Addendum No. 2
Naco Pump Station Improvements Project
SAWS Project No. 12-6003
Solicitation No. B-13-021-DD

**SAN ANTONIO WATER SYSTEM
NACO PUMP STATION IMPROVEMENTS PROJECT
SAWS PROJECT NO. 12-6003
SOLICITATION NO. B-13-021-DD
ADDENDUM NO. 2**

December 20, 2013

The purpose of this addendum is to issue a revision to the Contract Documents, plans and specifications for the Naco Pump Station Improvements Project (SAWS Job No. 12-6003).

SAN ANTONIO WATER SYSTEM NACO PUMP STATION IMPROVEMENTS PROJECT		ADDENDA NO.	EXHIBIT NO.
DATE 12/16/2013	SHEET NO. CSZ-05	LOCATION	2
		2	EB-CSZ-05

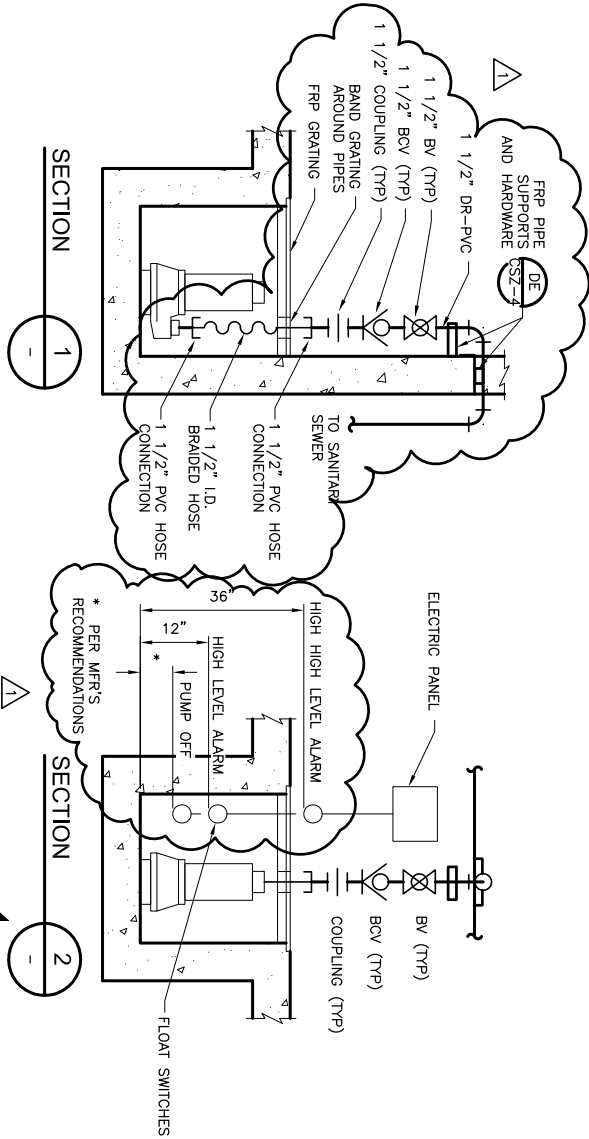
- EEEE. Sheet CSZ-05 - ADD the following note in Details EA:
- "1. See Specification Section 15062 for clarification on material requirements".
- FFFF. Sheet CSZ-05 - DELETE Detail EB in its entirety and REPLACE with the detail provided in Exhibit EB-CSZ-05.

EC-CSZ-05

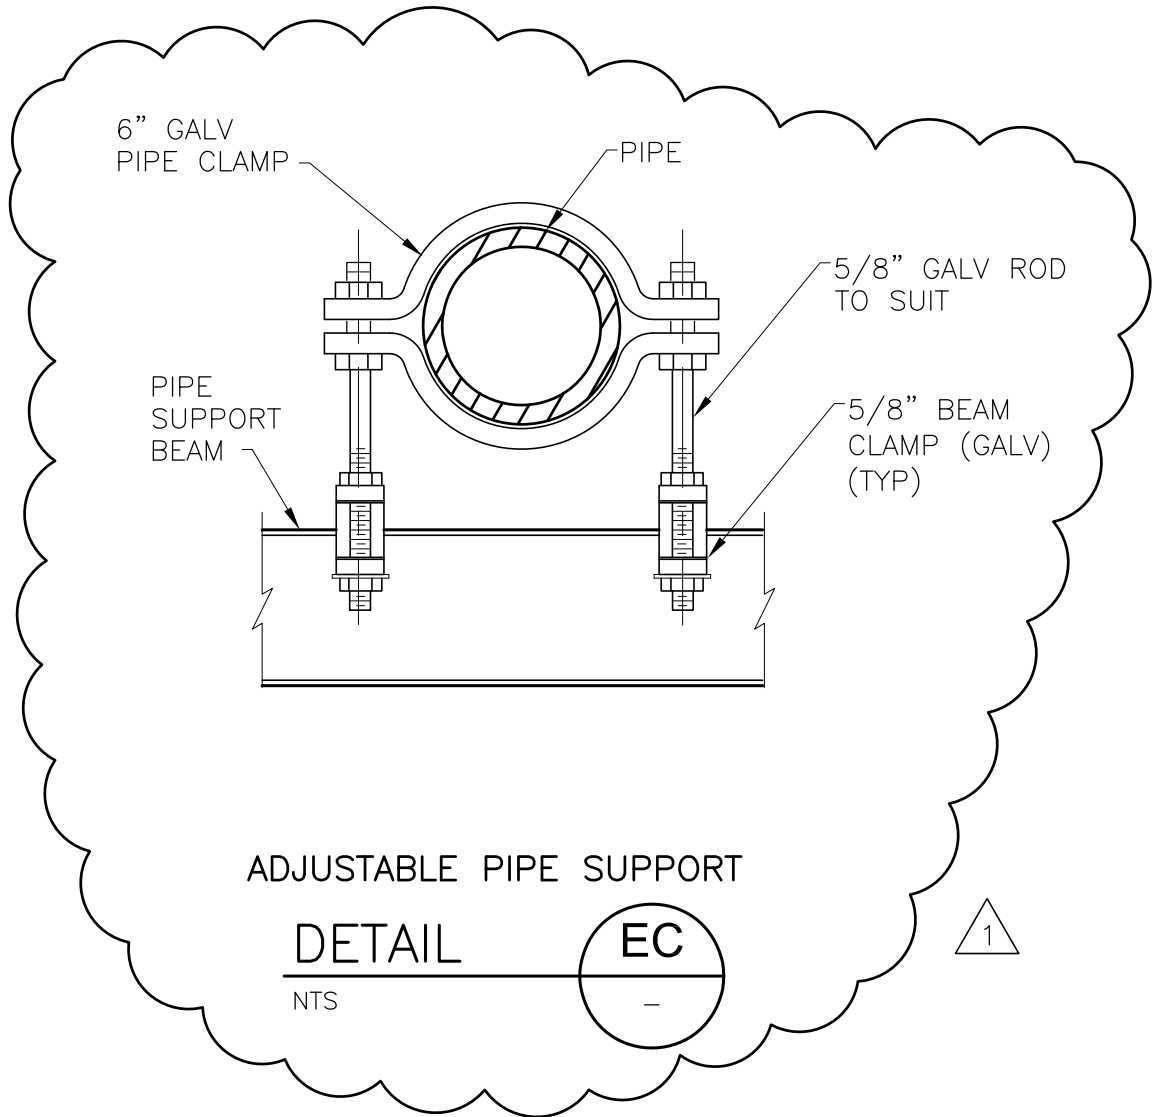
- GGGG. Sheet CSZ-05 - DELETE Detail EC in its entirety and REPLACE with the detail provided in Exhibit EC-CSZ-05.
- HHHH. Sheet CSZ-05 - ADD the following note in Details ED:
